MM11

digital	FIELD SERVICE TECHNICAL MANUAL				Option or Designator
	12 Bit <input type="checkbox"/>	16 Bit <input checked="" type="checkbox"/>	18 Bit <input type="checkbox"/>	36 Bit <input type="checkbox"/>	MM11

Engineering Change Order Log

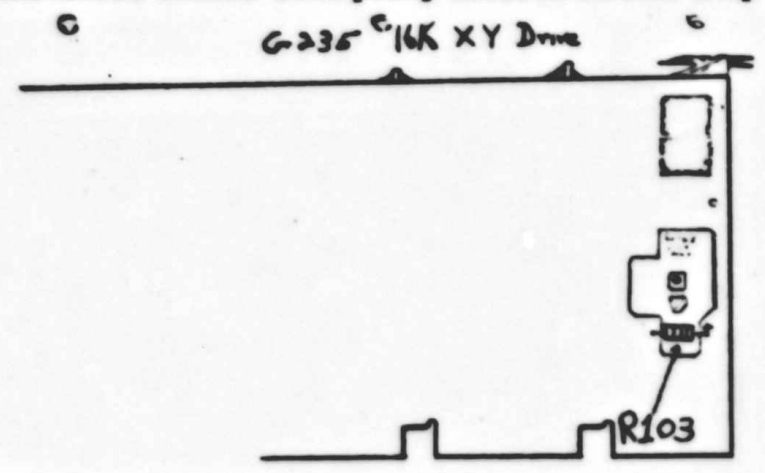
Many reports have been received from the field concerning memories failing high current margins and module set incompatibility (i.e. unable to swap modules). Investigation has shown that the inhibit margins are not properly centered, which could cause marginal operation of the memory under conditions of high drive currents. An ECO (G235-0009) was generated to correct this problem.

Therefore, if a memory exhibits these symptoms, do a visual inspection of the G235 for the ECO. A quick check for the ECO is:

1. Place G235 component side up and fingers toward you.
2. Look at right hand side of module in large etch area (see drawing).
3. If resistor R103 (75Ω 1W) which is across bottom of large etch is not in, ECO has not been installed.

ECO# MM11E-00016 D-AD-7006468-0-0

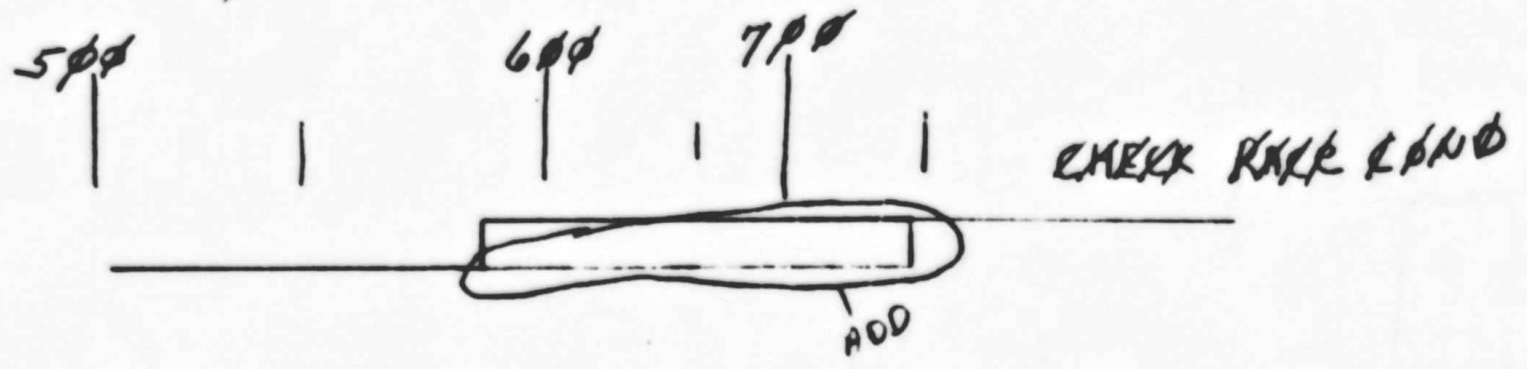
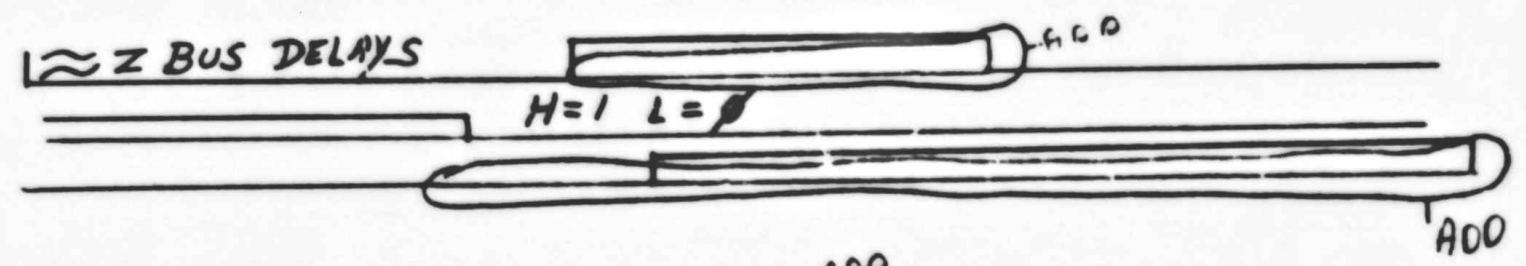
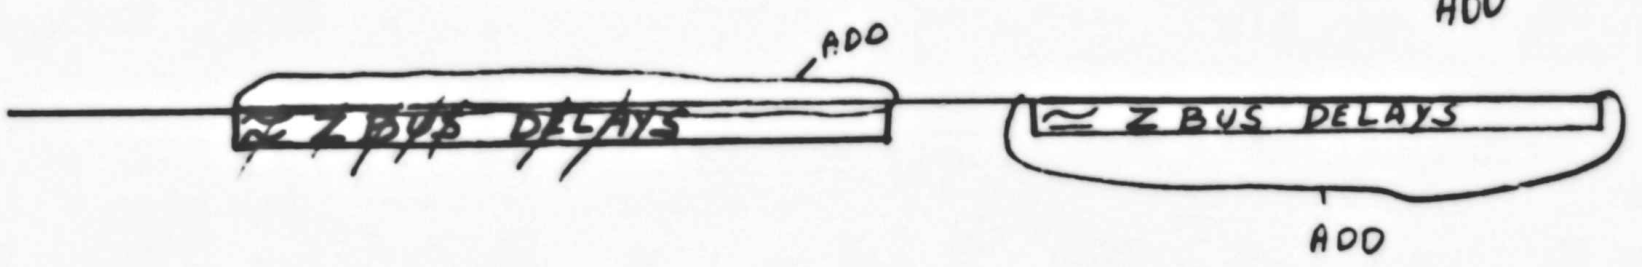
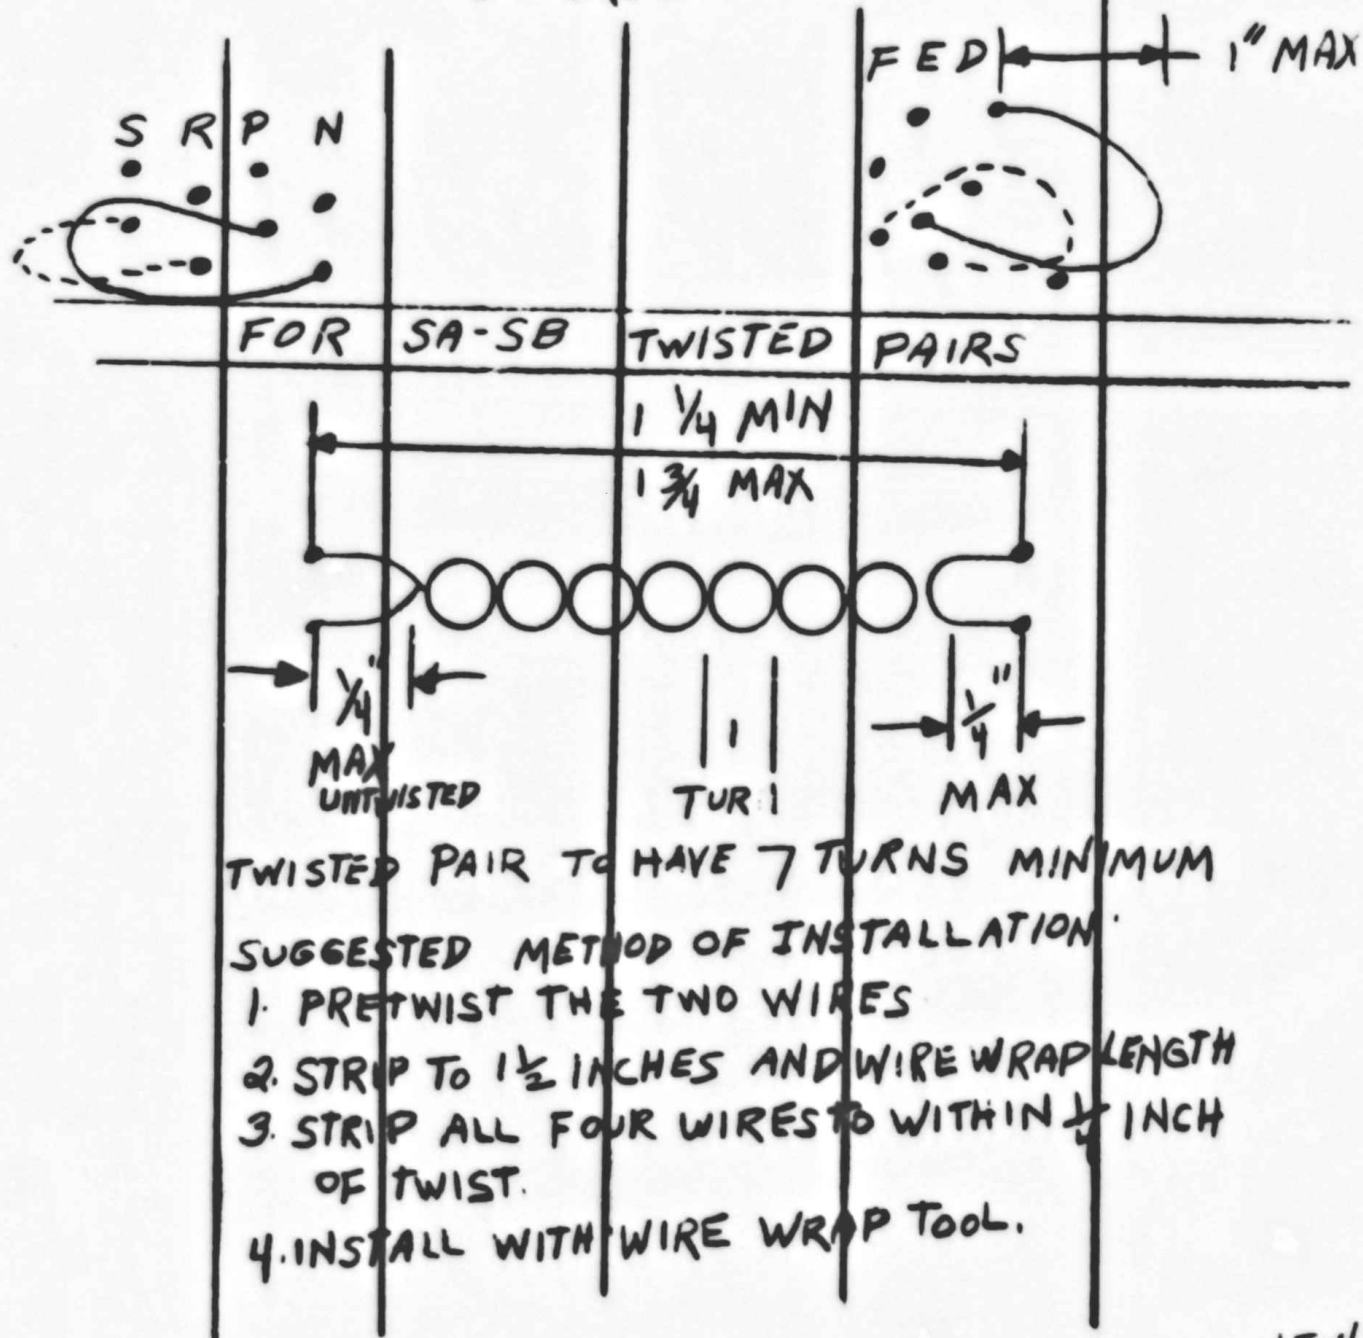
PROBLEM: <ol style="list-style-type: none"> 1. TIMING + FLOW DIAGRAM WRONG. 2. NOT ENOUGH INFORMATION GIVEN ON THE DRAWING TO INSURE THE REQUIRED RESULTS WHEN HAND WIRE. WRAPPING. TWISTED PAIRS WILL PICK BACK PLANE NOISE UNLESS DONE CORRECTLY. 	DRAWINGS AFFECTED

LENGTH SHOULD BE A MAXIMUM OF
 $2\frac{1}{4}$ INCHES. CHECK DRAWING FOR
 LENGTH AND FOR HOW LOOPS SHOULD
 BE DRESSED INTO LOGIC.

CORRECTION:	FIELD SERVICE CODED
<ol style="list-style-type: none"> 1. CORRECT TIMING + FLOW DIAGRAM 2. ADDITIONAL INFORMATION PUT ON THE PRINT. 	<u>D</u>

ECO# MM1E-00017

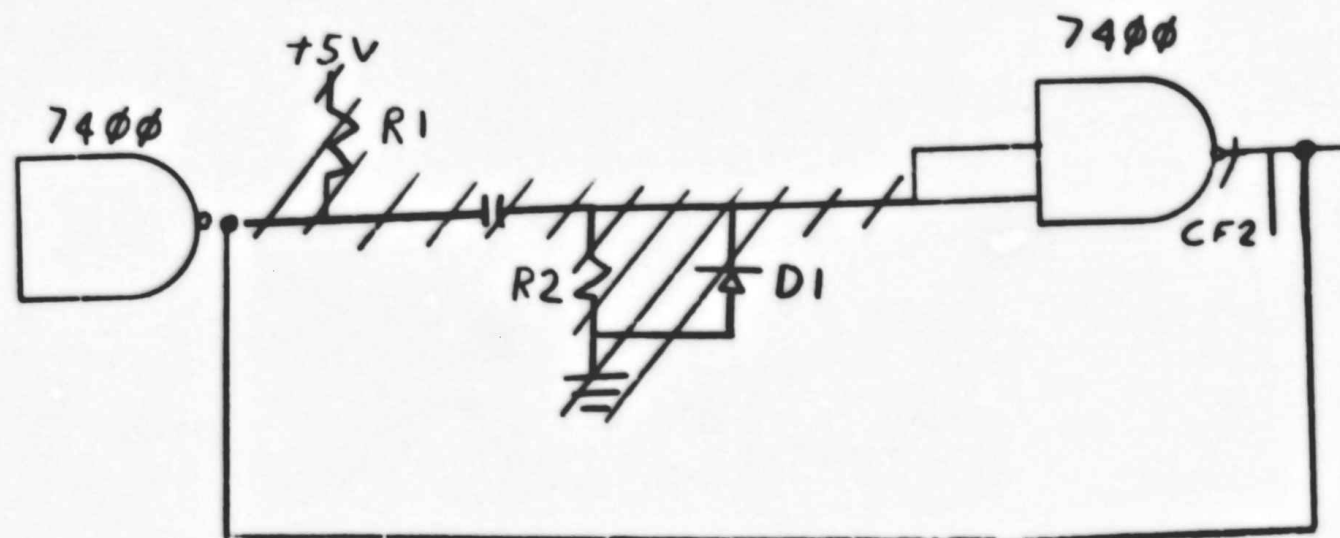
DRAWING CORRECTION <input checked="" type="checkbox"/>
				VENDOR <input type="checkbox"/>
PROBLEM				
1. WANTED TO IMPROVE MEMORY PERFORMANCE. STROBE 210 NS WAS TO EARLY FOR OPTIMUM PERFORMANCE . SOME TIMES CURRENT WAS TOO HIGH FOR OPTIMUM PERFORMANCE WHEN ADJUSTING THE REFERENCE VOLTAGE.

5. WRITING IN MARGIN				
CORRECTION				
1. CHANGED TEST PROCEDURE TO IMPROVE MEMORY PERFORMANCE.				
2. CORRECT WIRE LIST ACCORDING TO SUBMITTED ADD/DELETE SHEET.

3. UPDATE BLOCK SCHEMATIC PER ATTACHED MARKED UP PRINT.				
4. UPDATE TIMING AND FLOW DIAGRAM AS INDICATED .				
5. REMOVE WRITING FROM MARGIN.				
APPROVAL				
DESIGN ENGINEER	P. DURANT		ENG. MGR.	
PRODUCTION ENGINEER	D. CALL		FIELD SERVICE	
CHIEF ENGINEER			(ADVISORY)	J. BUZYNSKI

ECO NO MM11F-0003

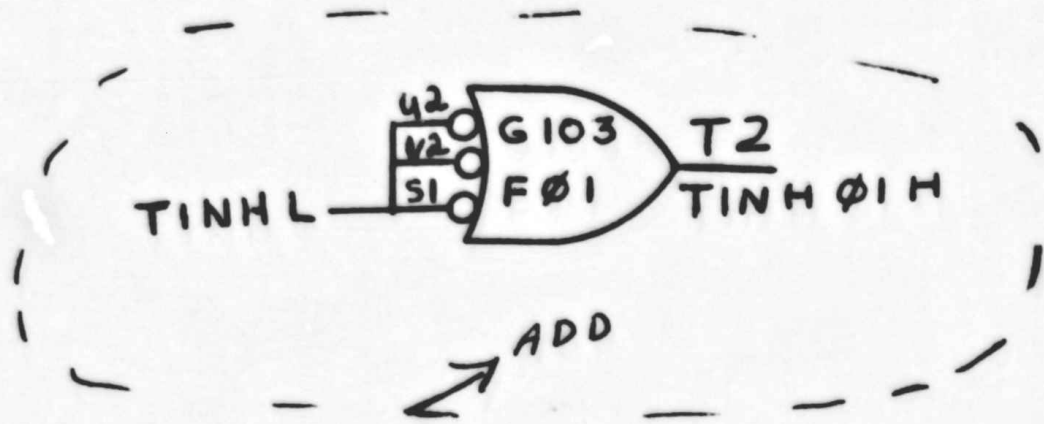
1. Strobe signals and TINH have too much noise on them.
2. Read H signal has too many loads on it.
3. Solves memory problems caused by DMA transfers that memory diagnostics don't show up, also, solves slot sensitive G103, G102 problems.

SIGNAL NAME	FROM PIN	TO PIN	COMPONENTS	ADD	DEL
TINH H	C01C1	D02E1			X
TINH H	D03E1	E03E1			X
TINH H	E01E1	F01E1			X
STROBE 00 H	C01R1	D02S1			X
STROBE 01 H	C01A1	E01S1			X
TSS H	F01V2	F01P1			X
TINH L	C01K1	F01S1		X	
TINH L	F01S1	F01U2		X	
TINH L	F01U2	F01V2		X	
TINH 00 H	C01C1	D02E1	WHT	TWP	X
GND	C01C2	D02C2	RED		X
TINH 01 H	F01T2	F01F1	WHT	TWP	X
GND	F01T1	F01C2	RED		X
TINH 01 H	F01T2	E02E1	WHT	TWP	X
GND	F01T1	E02C2	RED		X
STROBE 00 H	C01R1	D02S1	WHT	TWP	X
GND	C01T1	D02T1	RED		X
STROBE 01 H	C01A1	E01S1	WHT	TWP	X
GND	C01C2	E01T1	RED		X
